FINAL DRAINAGE PLAN SF 21-00X

SF-21-010

THE HILLS AT LORSON RANCH FIL. 1

**PCD-ENGINEERING REVIEW COMMENTS
IN BLUE BOXES WITH BLUE TEXT**

NOTE: AFTER CONCRETE STRUCTURE HAS BEEN POURED ALL GRATE DIMENSIONS SHALL BE FIELD VERIFIED PRIOR TO GRATE CONSTRUCTION

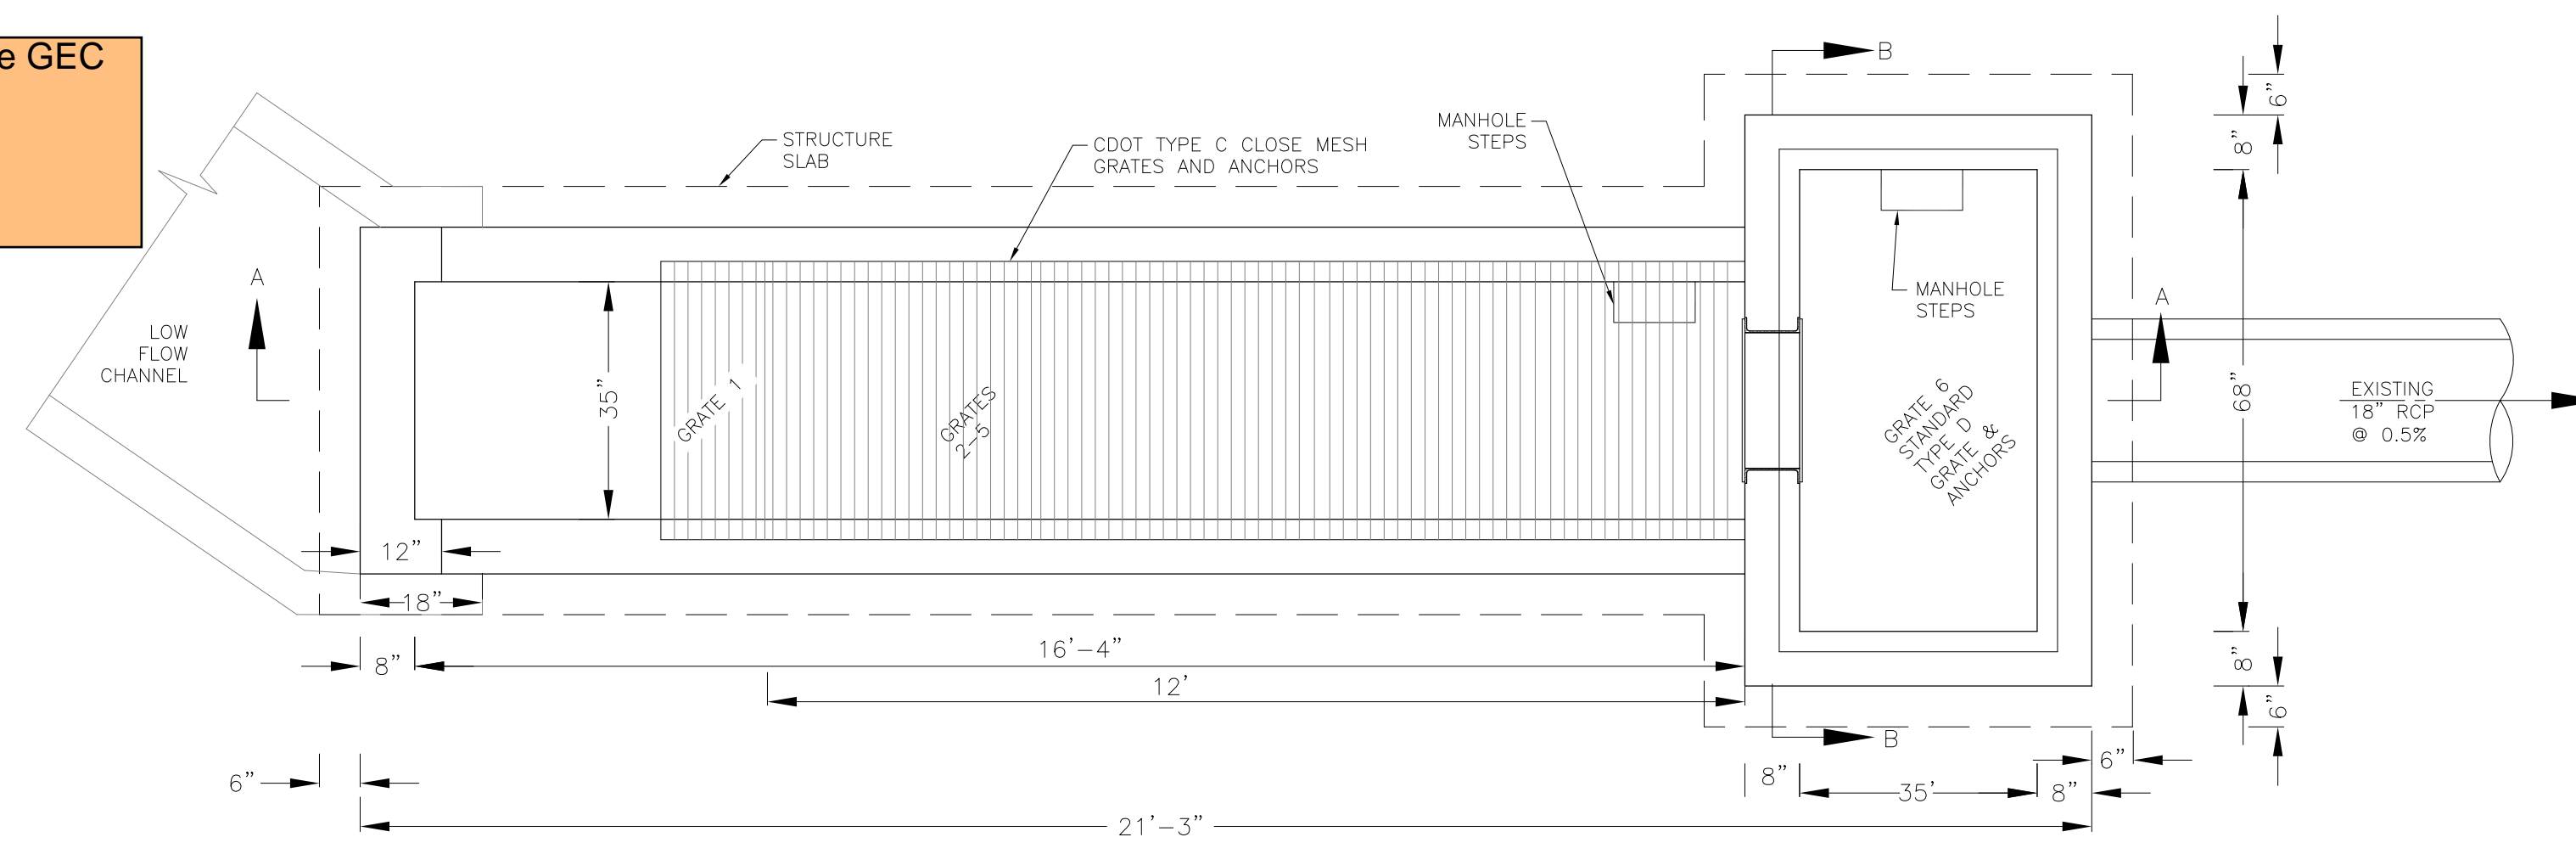
Include these pond details in the GEC Plan.
